REV	DATE	DETAILS	AMENDMENTS	BY	CHK
CLIENT:					
WDL Homes Making a house into your new home					
PROJECT:					
WDL Homes Trefechan					
DRAWING TITLE:					
S278 - Proposed Highway Layout					
DRAWN:		CHK:	STATUS:	SCALE:	
TL		SJD	Approval	1:200@A1	
DATE:		SUB NO.	DWG NO.	REV.	
Jan 20		1914	101	B

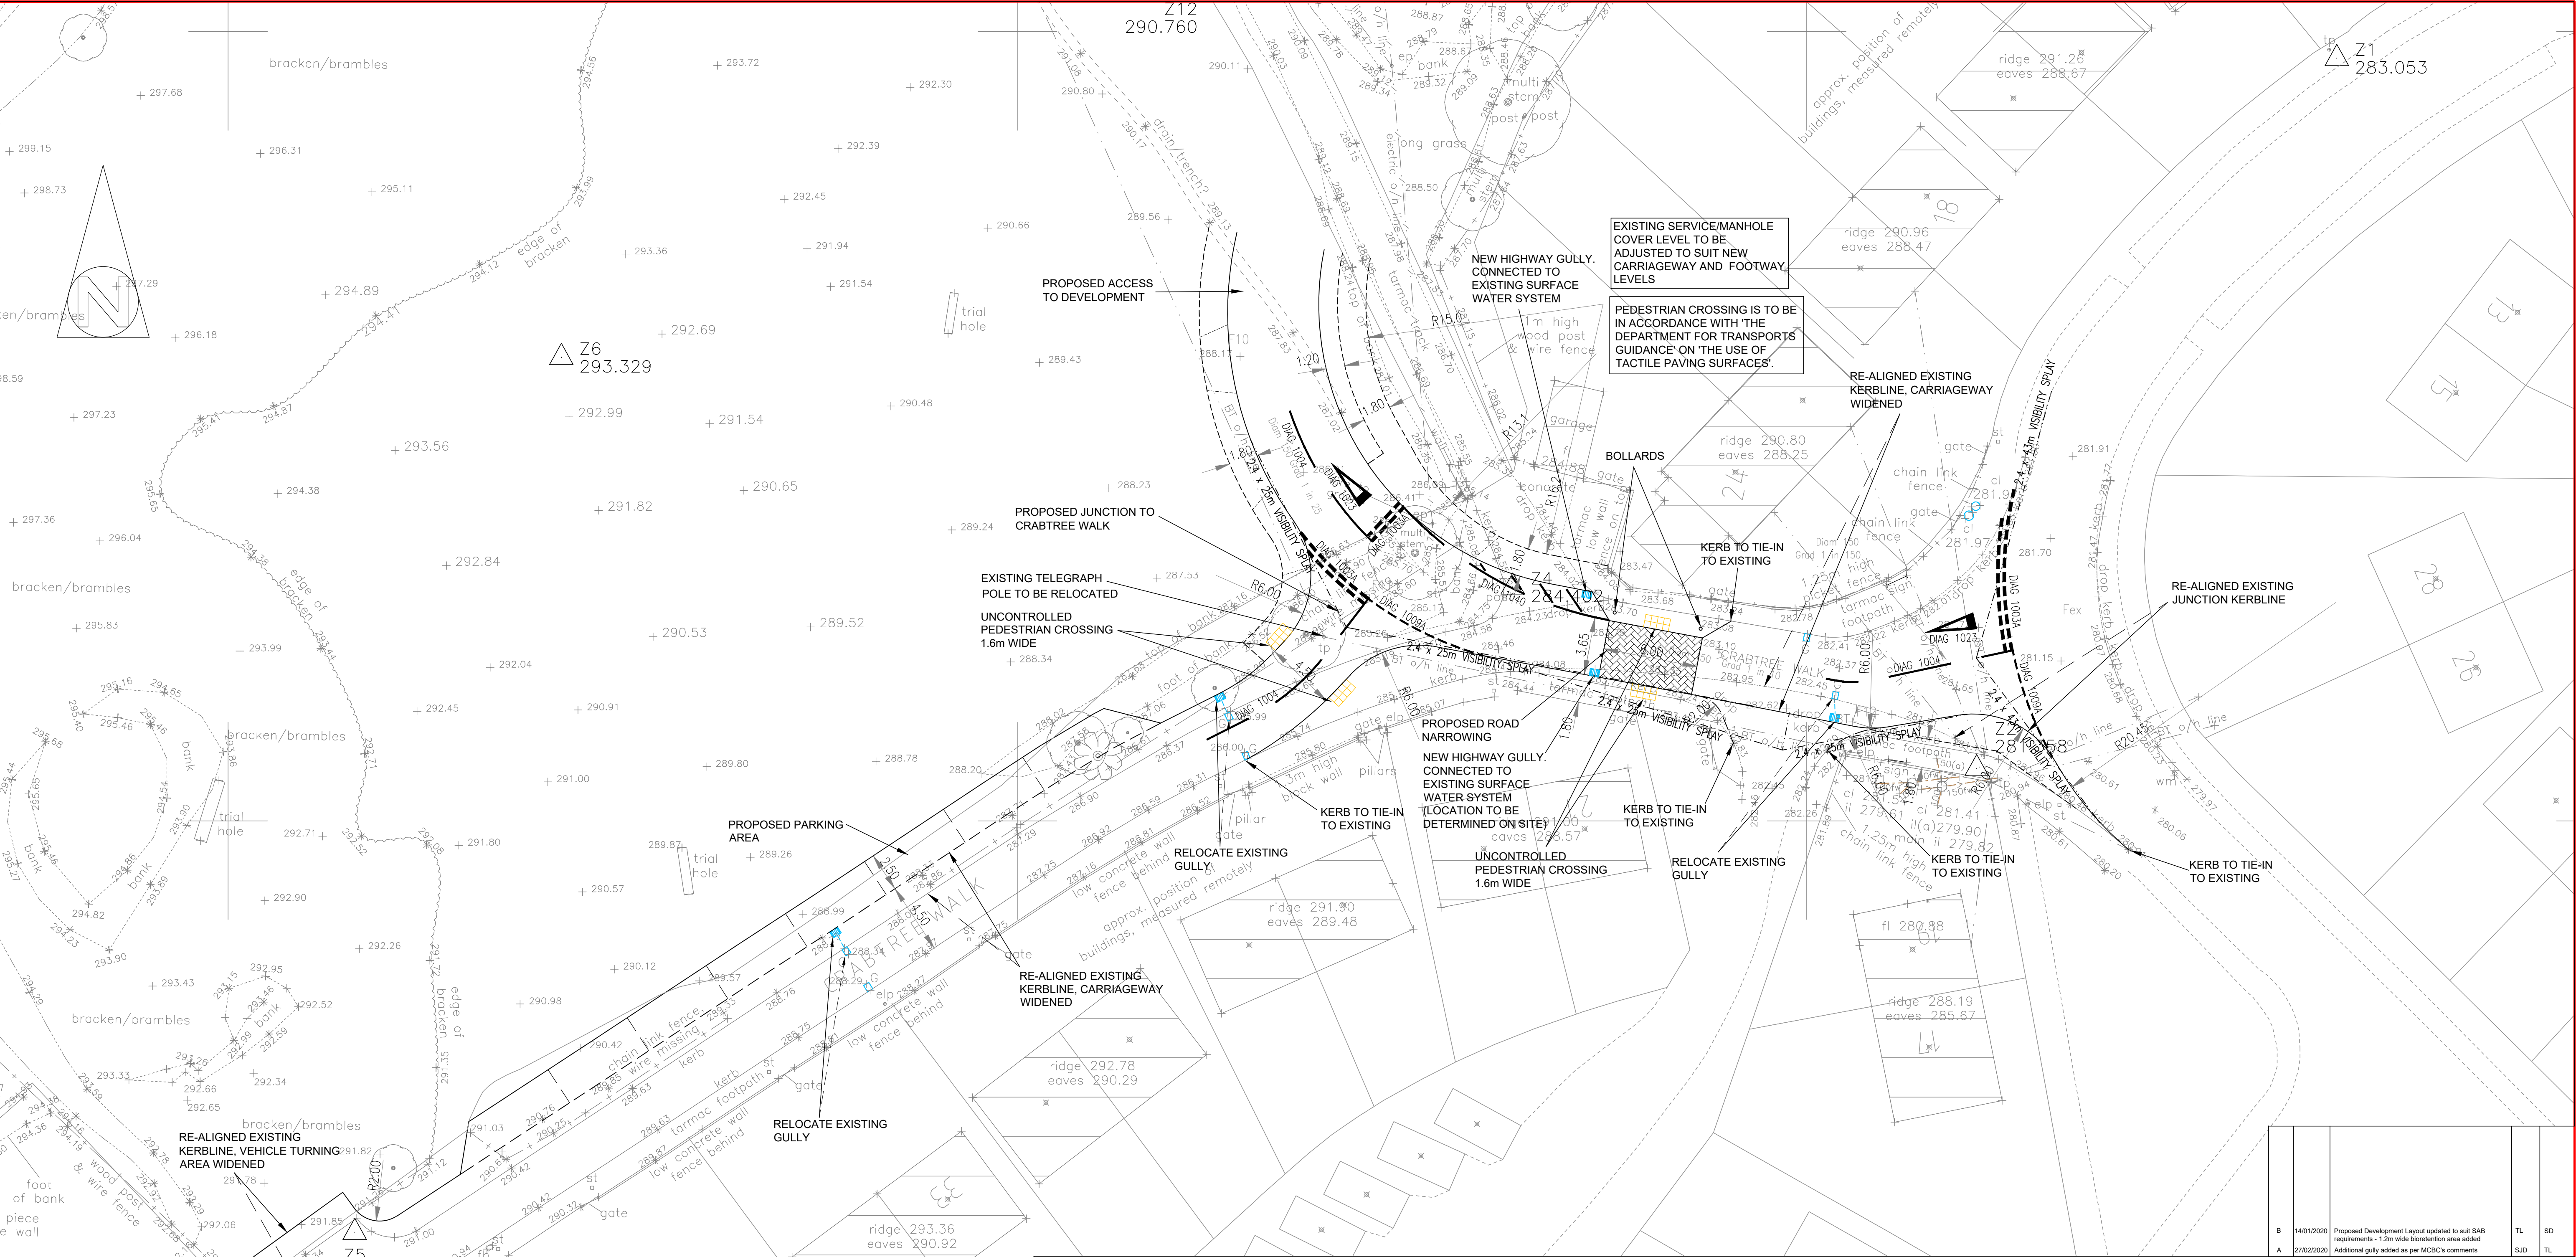
Proposed Development Layout updated to suit SAB requirements - 1.2m wide bioretention area added

Additional gully added as per MCB's comments
